SUBJECT: ISSUANCE OF AMENDMENT NO. 147 TO FACILITY OPERATING LICENSE  
NO. DPR-71 REGARDING MAXIMUM EXTENDED OPERATING DOMAIN -  
BRUNSWICK STEAM ELECTRIC PLANT, UNIT 1 (TAC NO. 75115)

AMENDMENT NO. 147 TO FACILITY OPERATING LICENSE NO. DPR-71 - BRUNSWICK, UNIT 1

Amendment No. 147  
License No. DPR-71

SAFETY EVALUATION BY THE OFFICE OF NUCLEAR REACTOR REGULATION  
SUPPORTING AMENDMENT NO. 147 TO FACILITY OPERATING LICENSE NO. DPR-71  
CAROLINA POWER & LIGHT COMPANY  
BRUNSWICK STEAM ELECTRIC PLANT, UNIT 1  
DOCKET NO. 50-325

Figure 2.2.1-1. APRM Flow Bias Scram Relationship to Normal Operating Conditions

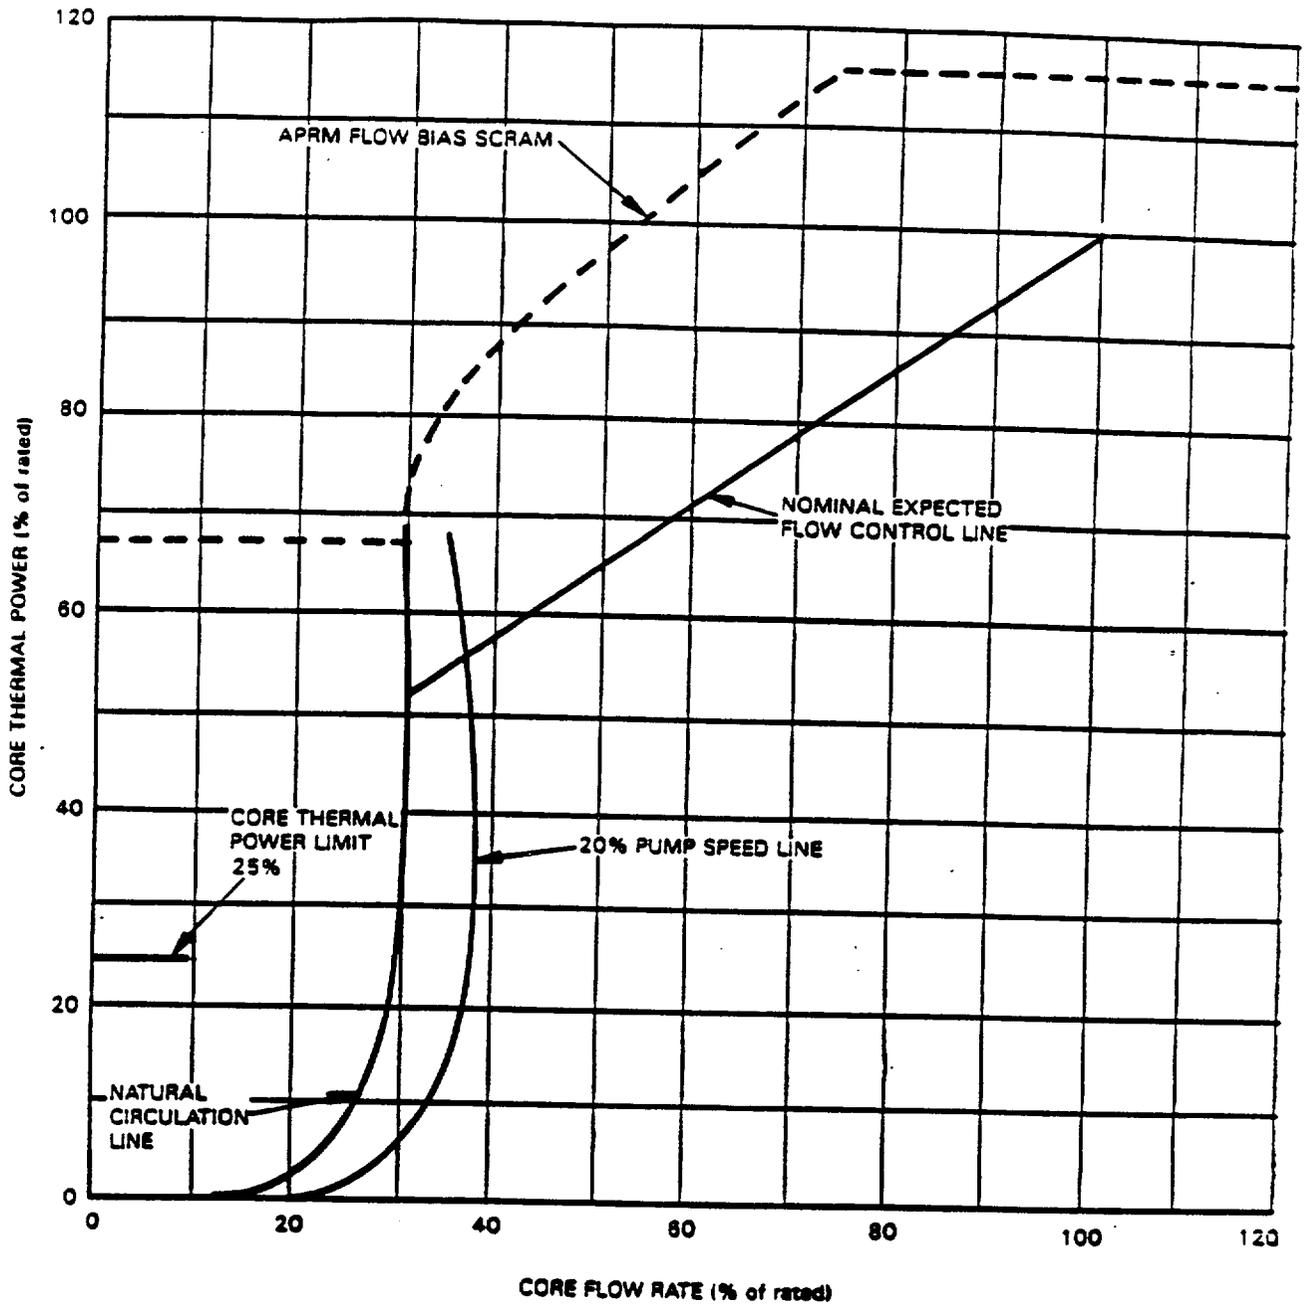
The MEOD proposal changes the flux scram lines on the power/flow map and permits operation up to the new APRM flux scram line ( $0.66W + 64$  percent) and up to the intersection with the 100 percent power line occurring at a flow of 75 percent. This is a standard change for MELLL. For ICF the proposed flow increase is to 105 percent core flow at 100 percent power with a linear expansion to 110 percent core flow at 70 percent power. The increased flow would be allowed throughout a plant cycle. The flow-biased rod block trip equation is changed to  $0.66W + 58$  percent with a maximum value of 108 percent. The maximum value of 108 percent necessitates a modification to establish a clamping function for the rod block trip level (see Section 2.5).

- (b) This Average Power Range Monitor scram function is a fixed point and is increased when the reactor mode switch is placed in the Run position.
- (c) The Average Power Range Monitor scram function is varied, Figure 2.2.1-1, as a function of the fraction of rated recirculation loop flow (W) in percent.
